TRANS/WP.29/GRSG/2002/9
29 July 2002

World Forum for the Harmonization of Vehicle Regulations (WP.29)

PROPOSAL FOR AMENDMENTS TO DRAFT REGULATION
UNIFORM TECHNICAL PROVISIONS CONCERNING
THE FORWARD FIELD OF VISION OF DRIVERS

Transmitted by the Expert from Japan

Figure 1

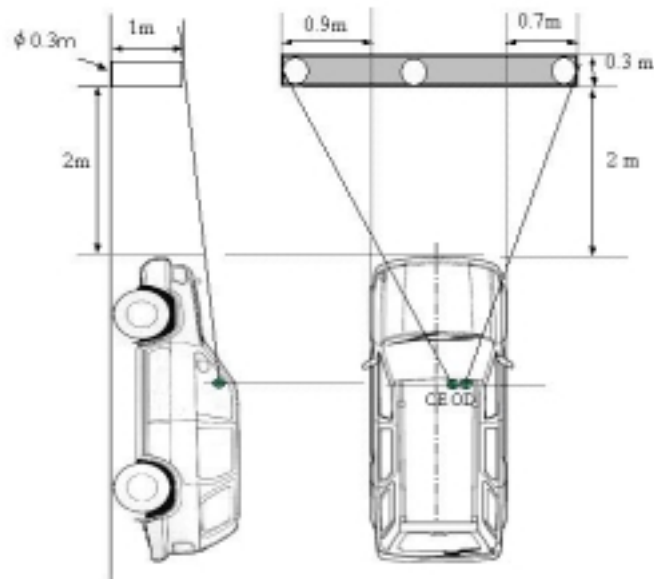
Insert a new paragraph 5.1.6., to read:

"5.1.6 In the case of a right-hand drive vehicle, a 1 m-tall cylinder with a diameter of 0.3 m located inside a space bounded by a vertical plane located 2.0 m in front of the vehicle, a vertical plane located 2.3 m in front of the vehicle, a vertical plane located 0.9 m from the left side of the vehicle, and a vertical plane located 0.7 m from the right side of the vehicle shall be at least partially visible from either point OD or point OE (see figure 1). In the case of a left-hand drive vehicle, substitute "right side" in place of "left side" and "left side" in place of "right side" in the above."
